CITY OF BATTLE CREEK

Historic District Commission Meeting

Staff Report

Subject: The petition, filed by Climax Solar, is for the issuance of a Certificate of Appropriateness for new roof top solar array structures at 28 Hanover Street pursuant to Zoning and Historic District Commission requirements.

A-103.00
(SHEET 3)

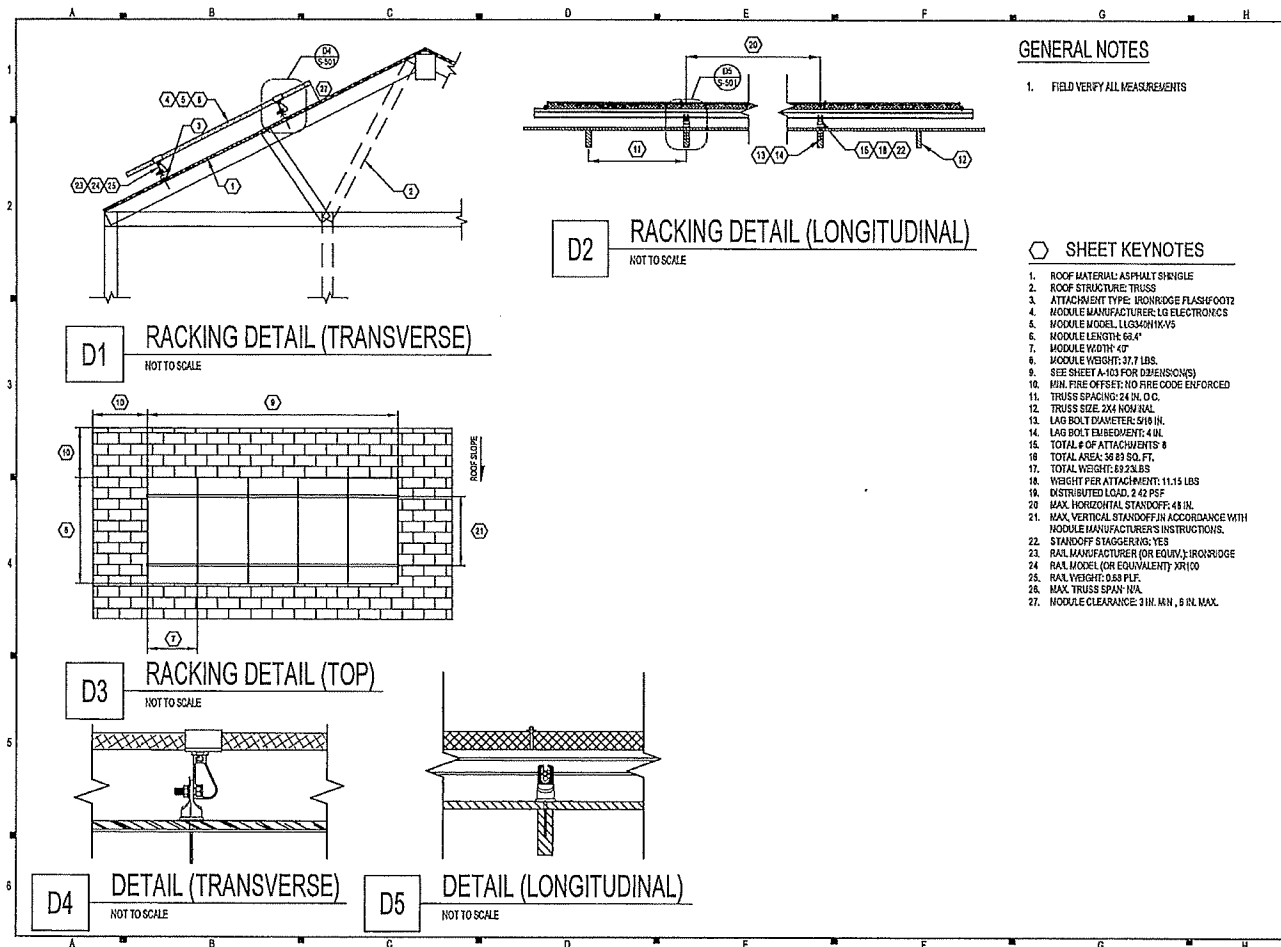
Since the site is located in a local historic district and some of the proposed roof top solar array structures will be visible from Hanover Street, the applicant filed the subject HDC Certificate of Appropriateness (No. H-12-21). Three roof top solar array structures are proposed: one on the garage, and two on the house. See attached plans for location and structure design. These structures consists of flat panels that mount several inches above the roof; each panel surface containing photovoltaic cells that capture and convert sunlight to energy (generally). The panels are designed to be parallel with the roof pitch thereto attached. All three solar arrays are on the south side of the roofs, intentionally angled to receive full sun light for solar array capture. The specific solar array locations can be seen attachment Sheet A-103.00.

The solar panels proposed on the garage (Figure 2) will not be easily visible from Hanover Street due to the garage's distant location from the street and the general difficulty of seeing the south side roof surface. The southeastern-proposed solar array on the house roof will also not be visible from the street due to the various roof pitches obscuring its view. However, the southwestern-proposed solar array

(Figure 3) on the house will be visible from the street but not very conspicuous due to the upward side angle of the roof and second-story elevation. Present-day pictures of the house and garage are provided in Figures 2 & 3.

Therefore, planning staff recommends approval of a Certificate of Appropriateness for new roof top solar array structures at 28 Hanover Street, as the request meets the standards outlined in Chapter 1470.09 "Review of Applications", Chapter 1470.17 "Preservation of Historic Features" and the Secretary of the Interior's Standards and Guidelines, as outlined in the staff report.

Figure 2. Arrows point to ten roof sections that will be replaced with metal sheets under the subject proposal. Aerial photograph provided by City of Battle Creek, dated April 2020 (approx.).

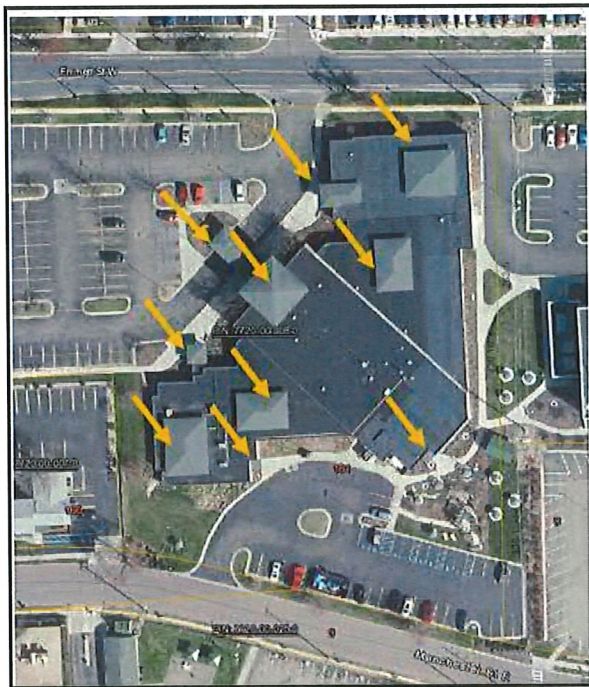
Since the proposed roof will consist of a different material and design than the existing roofing material, the applicant filed the subject HDC Certificate of Appropriateness (No. H-13-21). The subject request only affects the portions that consist of asphalt shingles (Figure 2). These areas are at the front and back entrances and the higher roof lines. According to the applicant, the existing shingled roofing material will be removed and replaced with a new underlayment and then new metal sheets as the outer layer. The chosen metal sheet product is a Meridian Snap Together Metal Roofing produced in 12" to 16" wide sections between the snap in ribs. An example image of the metal sheet design is attached. Also, details of this material can be found at their following website: <https://www.mcelroymetal.com/standing-seam-metal-roofing-systems/meridian>.

Therefore, planning staff recommends approval of a Certificate of Appropriateness for various new roof sections at 181 W. Emmett Street, as the request meets the standards outlined in Chapter 1470.09 "Review of Applications", Chapter 1470.17 "Preservation of Historic Features" and the Secretary of the Interior's Standards and Guidelines, as outlined in the staff report.

Figure 1: Arrow points to subject site along Frelinghuysen Ave. nearby Rose Street in the Old Maple Street local Historic district.

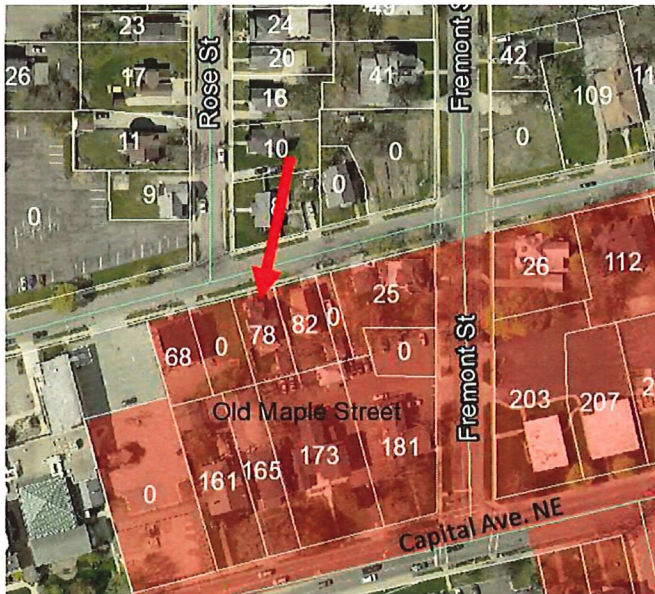
Structural instability has resulted from previous repairs that damaged the supports, floor and footings. Recent heavy rain events have also contributed to the rotting of the wood and added weight to the porch roof which cannot be supported by the damaged supports. This issue could worsen and affect the house, especially during winter months. Therefore, removing the porch to not compromise the remaining portions of the structure would improve the current safety hazard.

Planning staff is recommending that a Notice to Proceed be issued to the applicant for the demolition of the front porch structure at 68-70 Frelinghuysen if the Commission is satisfied that the Applicant can meet at least one of the criteria outlined in Chapter 1470.09(e) "Review of Applications". According to City's records, the building has been neglected and unmaintained for a number of years and retaining this element of the building at this time will cause undue financial hardship to the owner.

1. The gentlest means possible should be used when removing the front porch and repairing and installing weather proofing to the building.
2. The applicant shall take measurements of the porch, including its height, depth, and length, as well as measurements of the remaining supports and provide a detailed record to the City for the file and provide the same record to the future owner for use with reconstruction.
3. The foundation shall remain and stated in the applicant's scope of work.
